UNITED STATES
NUCLEAR REGULATORY COMMISSION
WASHINGTON, D.C. 20555-0001

September 22, 2020

SUBJECT: H. B. ROBINSON STEAM ELECTRIC PLANT, UNIT NO. 2 – STAFF REVIEW OF SEISMIC PROBABILISTIC RISK ASSESSMENT ASSOCIATED WITH REEVALUATED SEISMIC HAZARD IMPLEMENTATION OF THE NEAR-TERM TASK FORCE RECOMMENDATION 2.1: SEISMIC (EPID NO. L-2019-JLD-0022)

Figure 2 Layout of Turbine Building at the Ground Floor Level

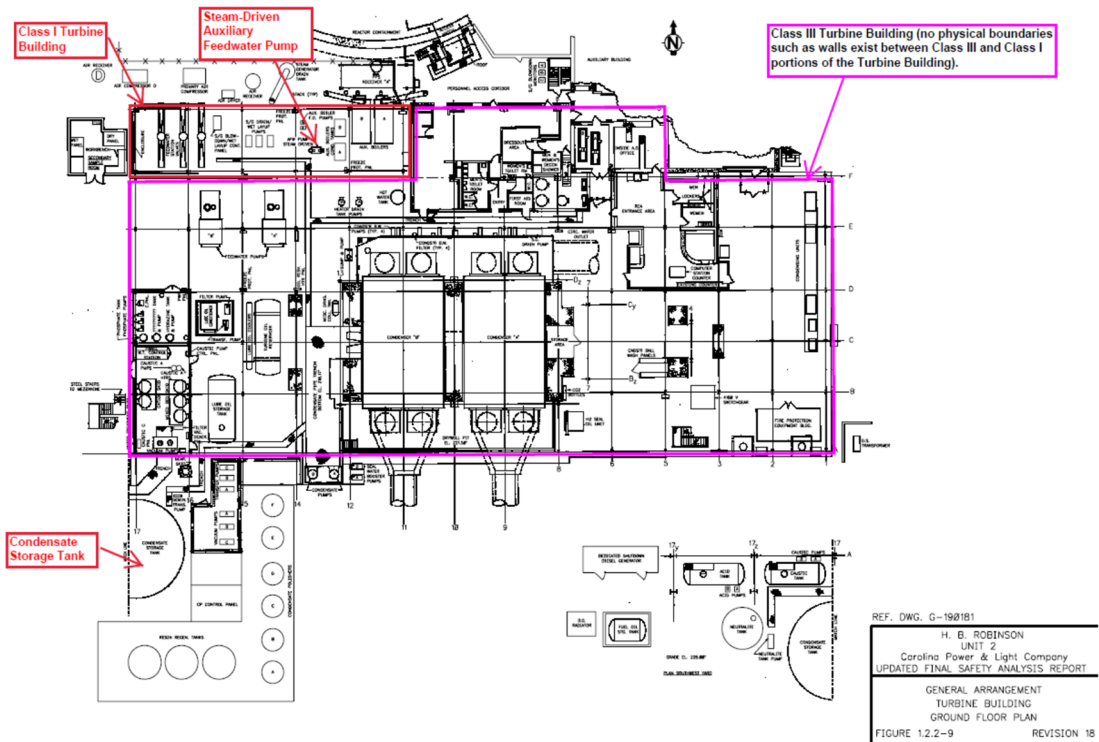
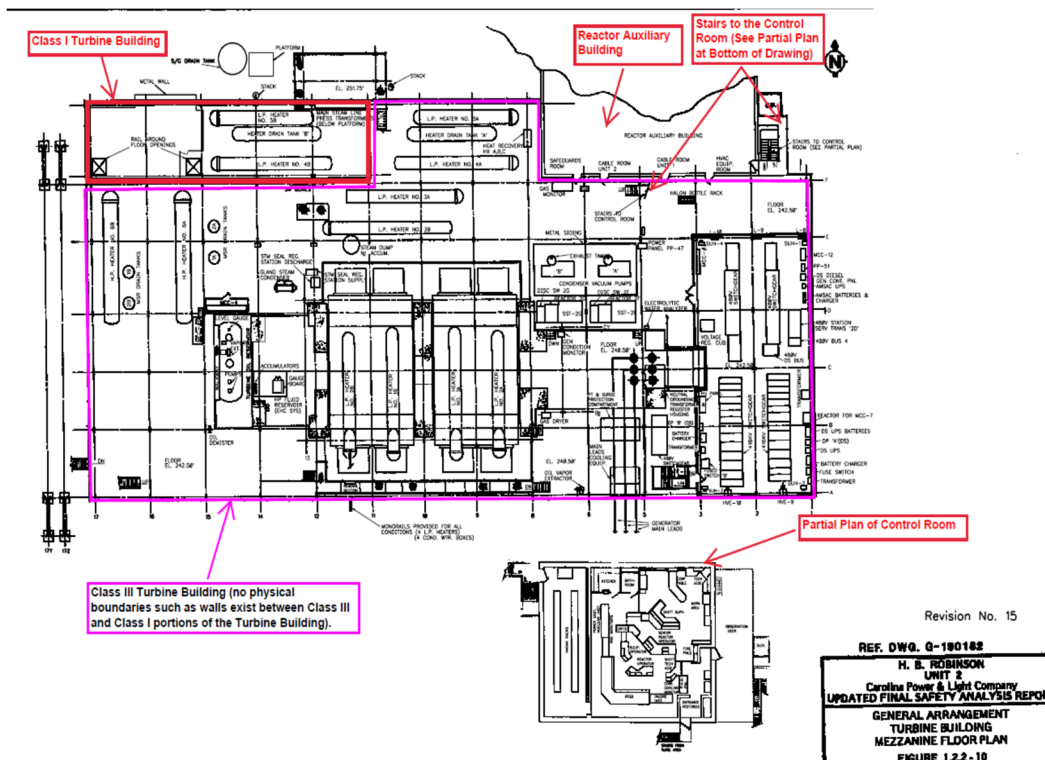
Figure 2 and Figure 3 shown the layout of the TB at Robinson at the ground and mezzanine floor level, respectively. Figure 2 and Figure 3 also identify certain SSCs relied upon for mitigation to demonstrate location and proximity to the Class III TB. Figure 4 shows a cross section of the Robinson dam.
